Launch of new drum brake SNK300x200S for 12t in July 2016

The SNK 300x200 brake size has a range of application covering axle loads from 6t to 12t. The large number of variants and the increasingly strict ECE R13 legal requirements made it necessary to develop a special solution for 12t applications. SAF-HOLLAND has thus re-worked the SNK brake in order to continue to be able to meet customer requirements. The result is the new **SNK300x200S** brake for a max. **axle load of 12t**.

Fig. 1: SAF SKxxxx 12030S

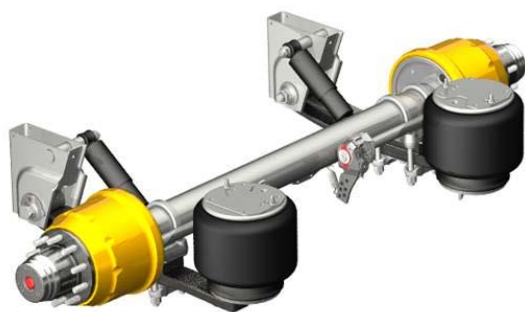
The new brake will be launched as part of the changeover from the familiar SKxxxx 12030 axle versions to the new **SKxxxx 12030S** axle version. This applies for all rigid and steering axles.

Axle model	Axle type	Brake type	Test report	Axle load
old	SKxxxx 12030	SNK3020	SNK300x200	TDB0487	11.6t
new	SKxxxx 12030S	SNK3020	SNK300x200S	TDB0882	12t

Fig. 2: Brake lining SAF636

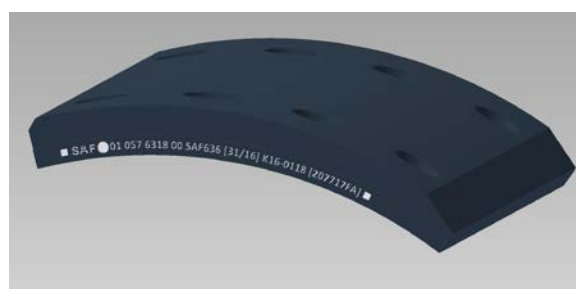
As well as various construction changes, the new brake has the optimized **SAF636** brake lining. This lining has been specially developed for use with 12t axle loads.

- Application-specific brake lining fade value
- Adjustment of braking factor
- Brake fade stability over the entire service life of the lining.
- Brake fade stability related to temperature, speed and pressure.
